RE: Docket 272: Proposed Changes to the Segment 1a D&M Plan – Change Request 1

On March 8, 2006, the Connecticut Siting Council (Council) conditionally approved the Segment 1a D&M Plan filed by The Connecticut Light and Power Company (CL&P) for overhead construction in Middletown, Haddam, Durham, Middlefield, Meriden and Wallingford. Subsequent to the approval of the Segment 1a D&M Plan, CL&P has made revisions to Volume 2 with respect to structure heights and access roads as final foundation design and engineering of Segment 1a is completed. Enclosed are an original and five (5) copies of the revised drawings.

NORTHEAST UTILITIES SERVICE CO. FOR THE CONNECTICUT LIGHT & POWER COMPANY BERLIN, CONNECTICUT			
		TITLE TYPICAL FOUNDATIONS			
BY	RDG	CHKD	APP	DEH	APP
DATE	2/17/05	DATE	DATE	3/21/05	DATE
SCALE	NTS	MICROFILM DATE	DWG NO 01227-80001		
P.A #		PROJ	V.S.

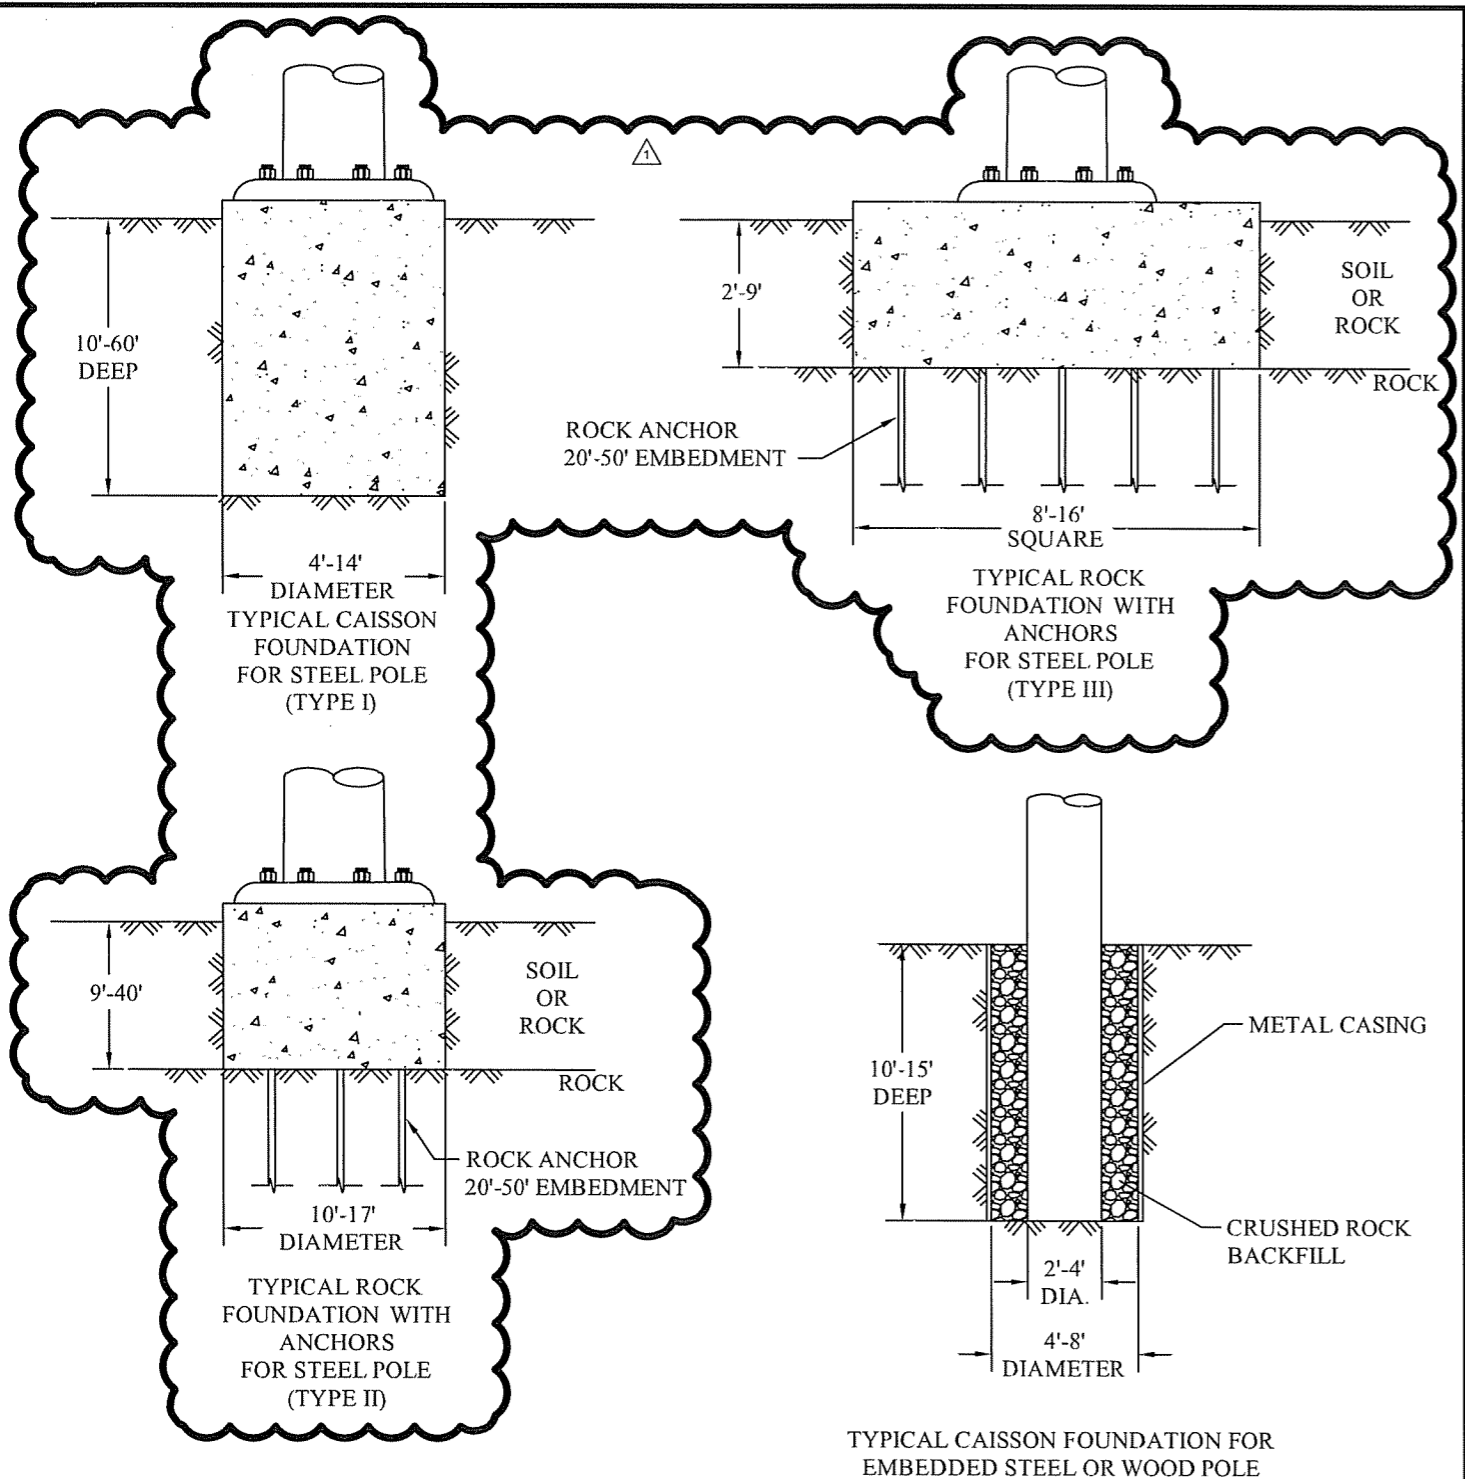
NO	DATE	REVISIONS	BY	CHK	APP	APP
1	10/16/06	REVISED DETAILS TO REFLECT ANTICIPATED DESIGN	JPB	JMH

- Revised to reflect the final foundation design for construction.
